Re: Finance Docket No. 36284 - Seven County Infrastructure Coalition - Uinta Basin  
Railway Project - Response to Information Request No. 4

Seven County Infrastructure Coalition's Response to the  
STB Office of Environmental Analysis October 30, 2019  
Request for Information No. 4

**Figure 1: Map of Avintaquin Canyon Route**

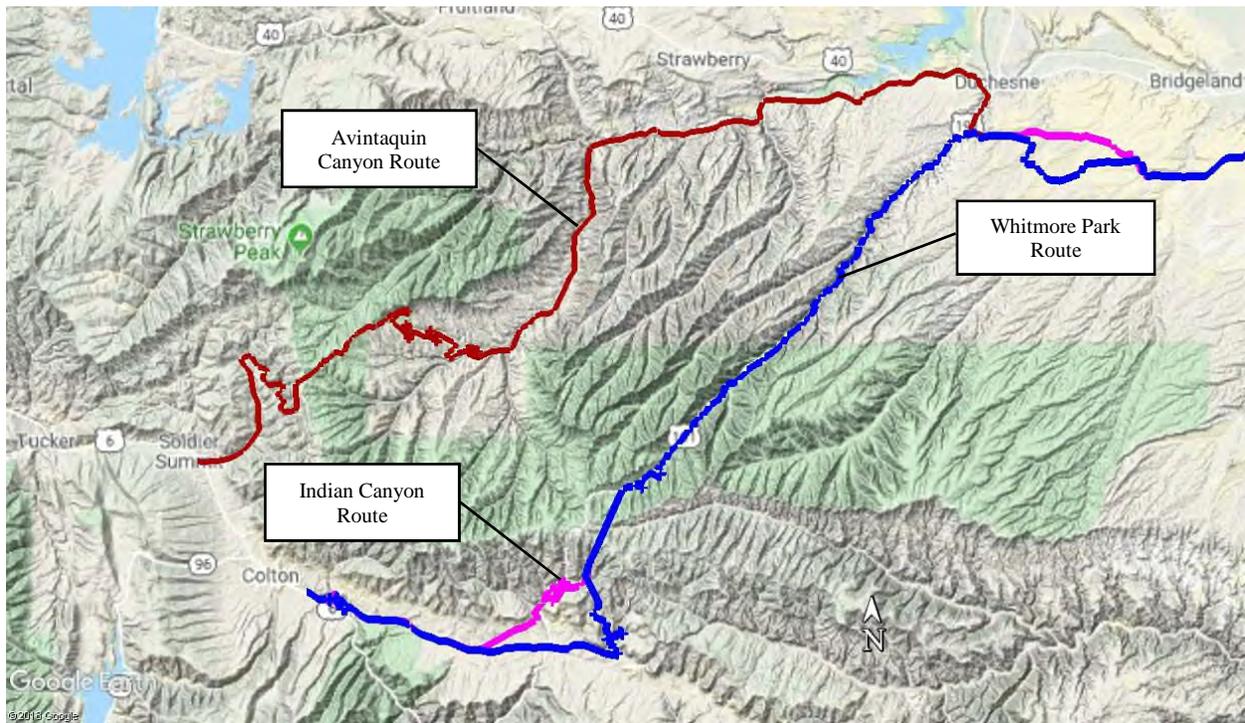
**c. Please provide any additional information (such as ruling grade, curve radius, cut-and-fill volumes, or tunnel design details) that the Coalition considered in evaluating the feasibility of the Avintaquin Canyon Route.**

**Coalition Response:** The Avintaquin Canyon Route was based on a route surveyed, but never constructed, by the D&RGW Railway in 1925. The D&RGW Railway route was used as a starting point and modified as appropriate to achieve proposed design standards for the Uinta Basin Railway. A map of the Avintaquin Canyon Route, identified by the red route line, is provided in Figure 1. In order to achieve the maximum gradient established for the Uinta Basin Railway, the route follows a circuitous path that lies on angle-of-repose mountain slopes. This circuitous path is necessary both to avoid areas of great relief and tunneling, as well as to meet maximum grade requirements.
